12/28/1990
DEPARTMENT OF THE AIR FORCE
HEADQUARTERS 27TH COMBAT SUPPORT GROUP (TAC)
CANNON AIR FORCE BASE NM 88103

RE: Compliance Order/Schedule, Docket Number 901002
Cannon Air Force Base, NM7572124454

Construction Deviations in Closure of Landfill 5, Cell 3

FIGURE 1

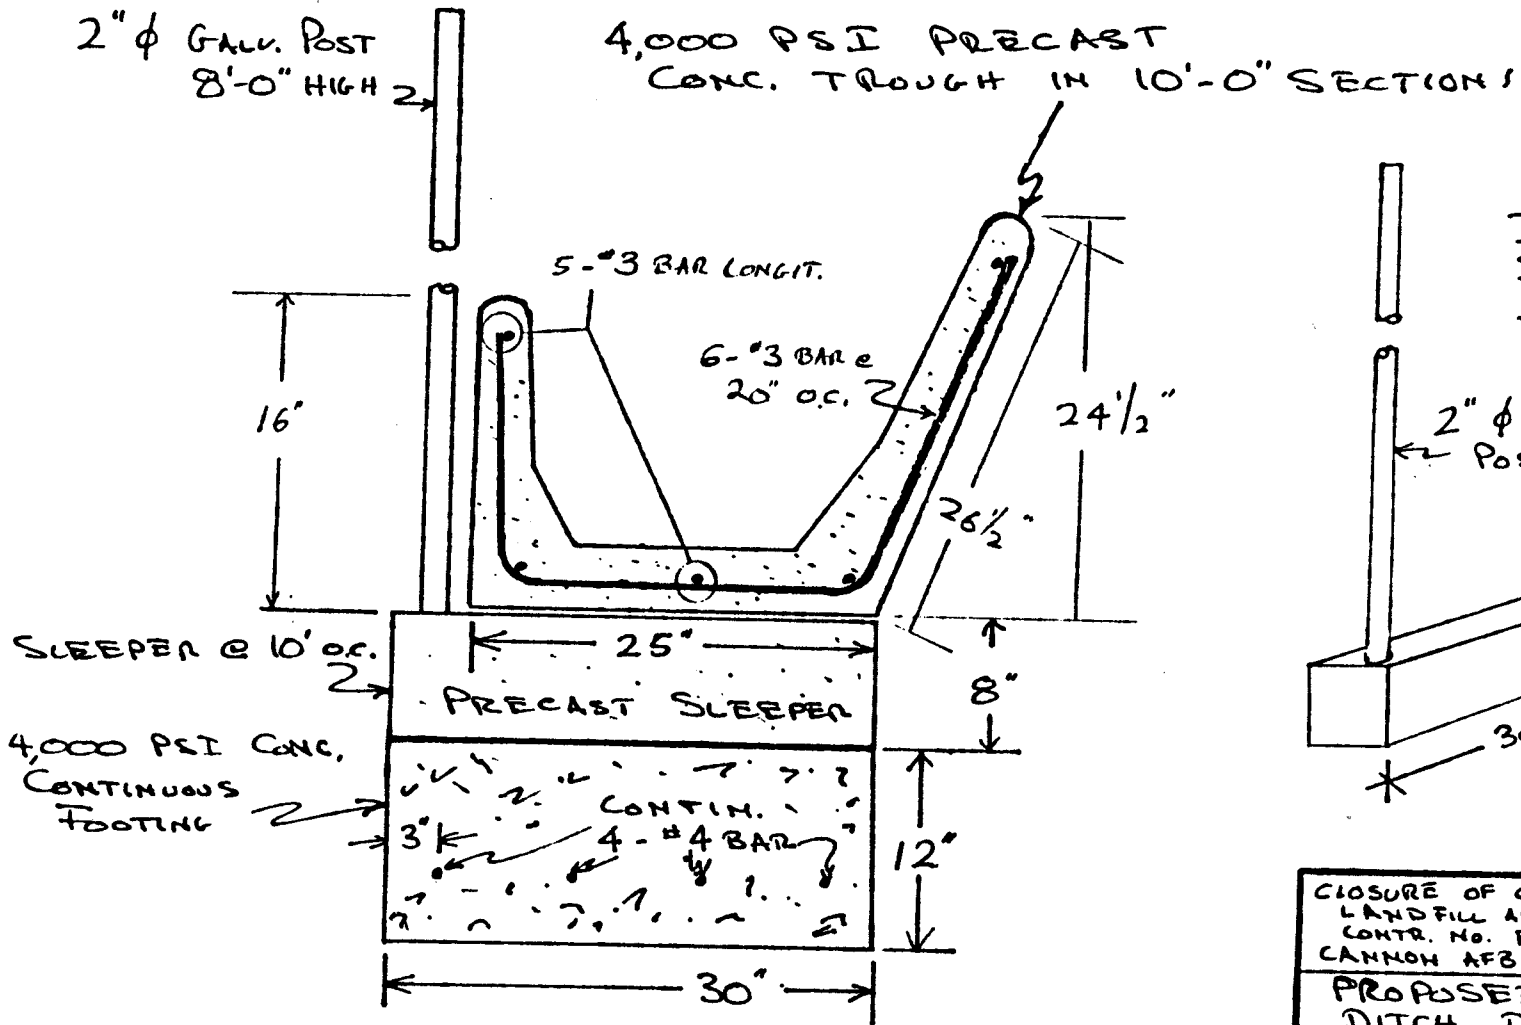
1. The fence post footings were installed in an eight-inch thick precast sleeper as illustrated in Figure 1. Section 3.2.1 on page 2E-2 of the Cannon Air Force Base Closure of Cell No. 3 of Landfill 5 - Designs and Specifications (Specs) document noted that the posts were to be anchored as shown in the construction drawings. Sheet 4 of the drawings indicates that the footing dimensions were to be 12x12x18 inches. The footings were originally designed assuming that the landfill material was buried 24 inches below the ground surface (Specs, Section 2B, Item 2, p. 2B-7); the footings were re-designed because landfill material was encountered 6 inches below the ground surface.

3. The dimensions of the precast gutter drain (Figure 1) differ from the dimensions shown on Sheet 5 of the construction drawings. A commercially available precast gutter drain was used per Item 2.1.1 of Section 2C on page 2C-1 of the Specs. The revised gutter drain drawings were sent to the EID prior to the installation of the gutter drain.

4. The gutter drain was constructed with continuous wire reinforcement in lieu of the welded wire fabric called for in Item 2.1.2 of Section 2C on page 2C-1 of the Specs. The gutter drain was constructed with locally available precast troughs that were available only with continuous reinforcement wire.

At that point we elected to use the available pre-cast trough units from the local supplier rather than re-design the drain trough. This did require us to re-design the footing, but that was simple enough for us to quickly handle.

3. The third difference, mentioned above, was the installation of differently shaped drain trough components. The footing was installed as a continuous, continuously reinforced with concrete reinforcing bars in lieu of welded wire fabric, concrete structure, one foot thick to provide a stable base for the drain trough units. The footing is able to bridge any weak soil pockets which may develop, as often happens along the edges of landfill cells. The footing is also able to resist lateral earth pressures from the call cap. This feature was enhanced by the added sloped fill we installed at the outboard side of the drain trough.

The drain trough was installed using locally available units which were installed to drain the runoff from the cap along the available gradient at the site. This change was approved prior to implementation. This change carries the added feature of having locally available replacement units should the need arise.
